ECN/PCN No.: 4099

For Manufacturer			
Product Description: Oven Controlled Crystal Oscillator	Abrakon Part Number / Part Series: AOCJY	☐ Documentation only	☒ Series
		☒ ECN	☐ Part Number
Affected Revision: F	New Revision: G	☐ EOL	
		Application:	☐ Safety ☒ Non-Safety

Prior to Change:

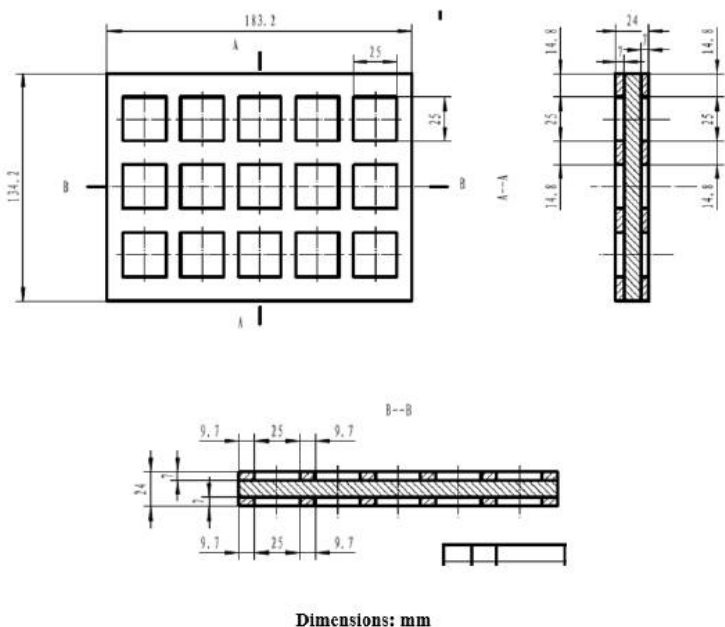
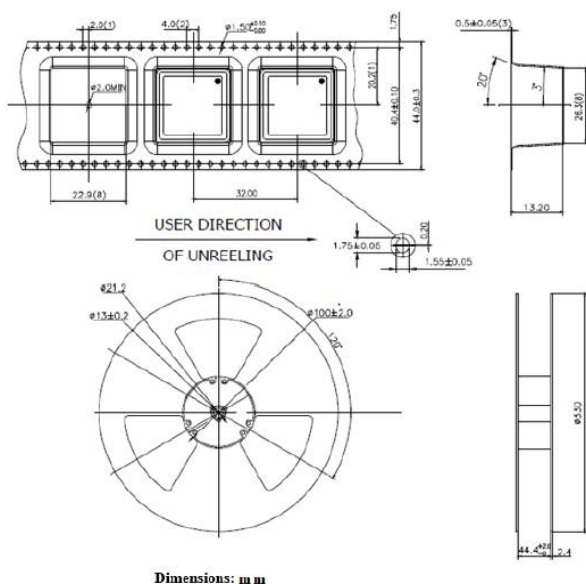
Packaging: (15) units per tray

Packaging

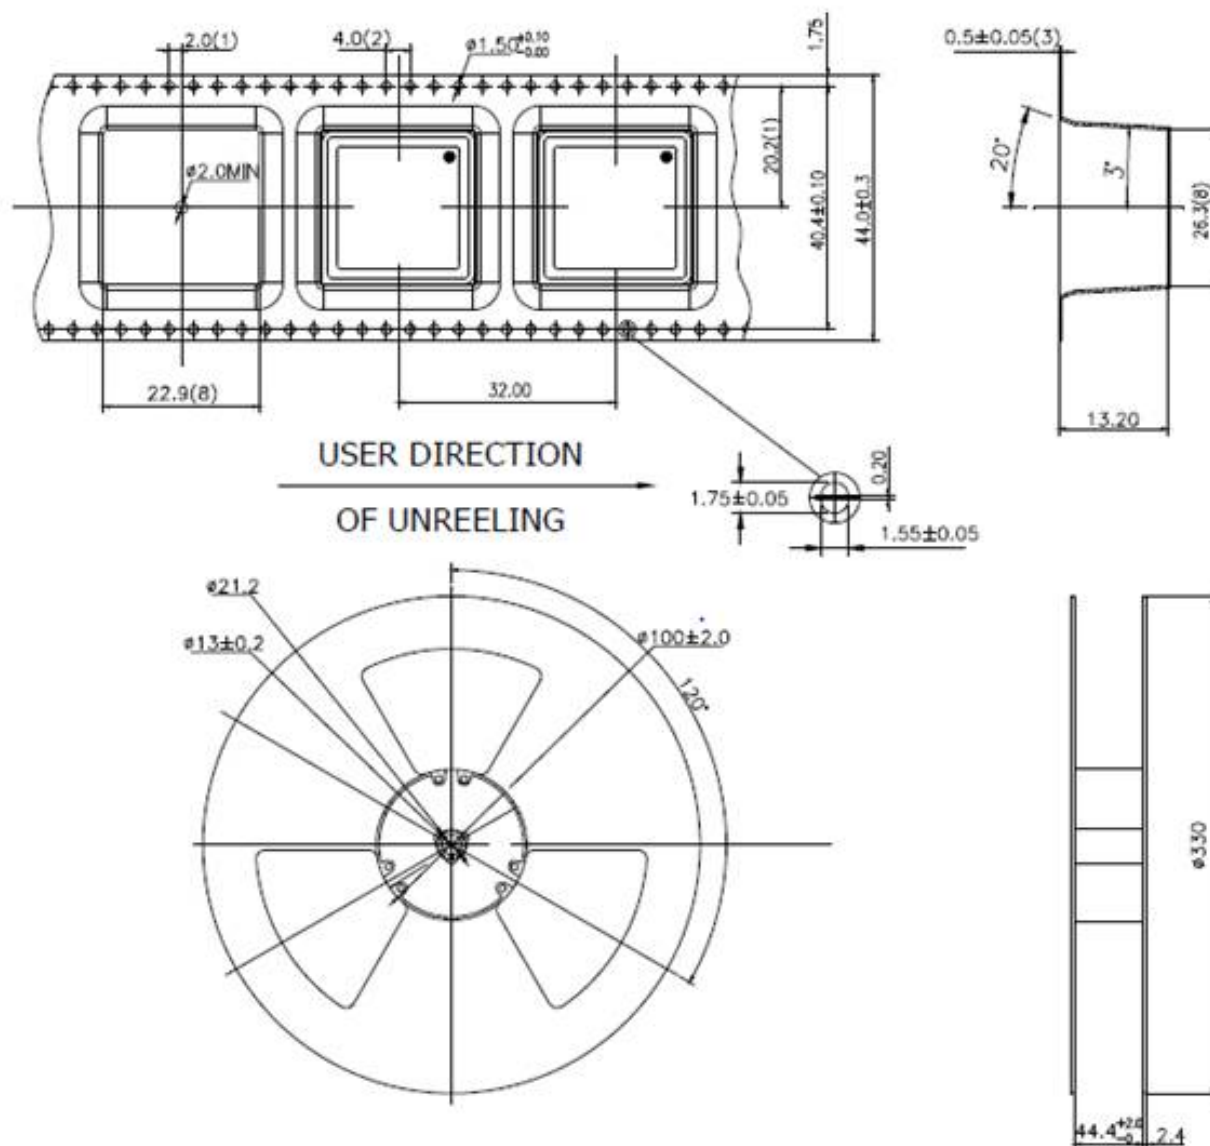
Tape & Reel=50 units

Tape & Reel packaging applies to MOQ>30 units

(15) units per tray

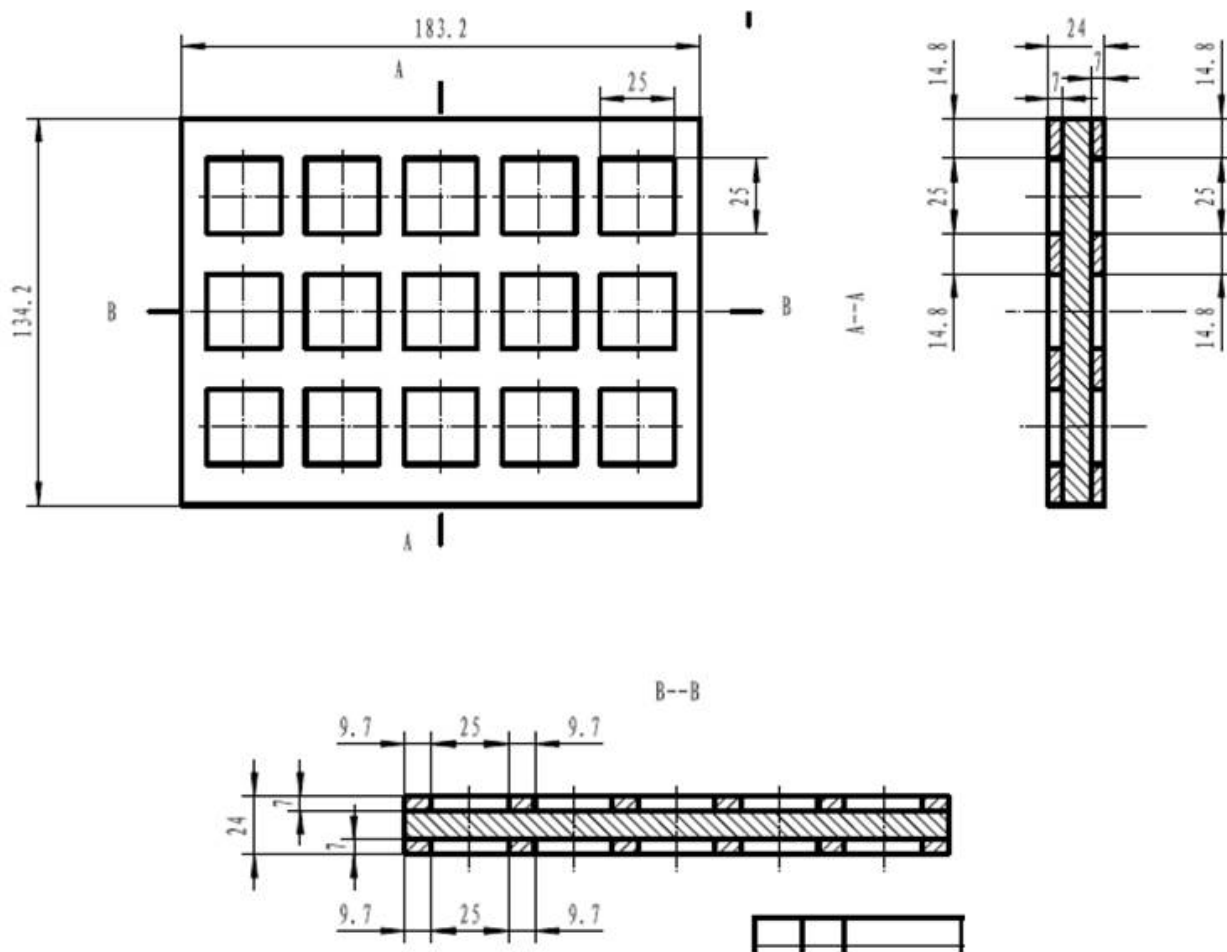
Tray packaging applies to MOQ less than or equal to 30 units
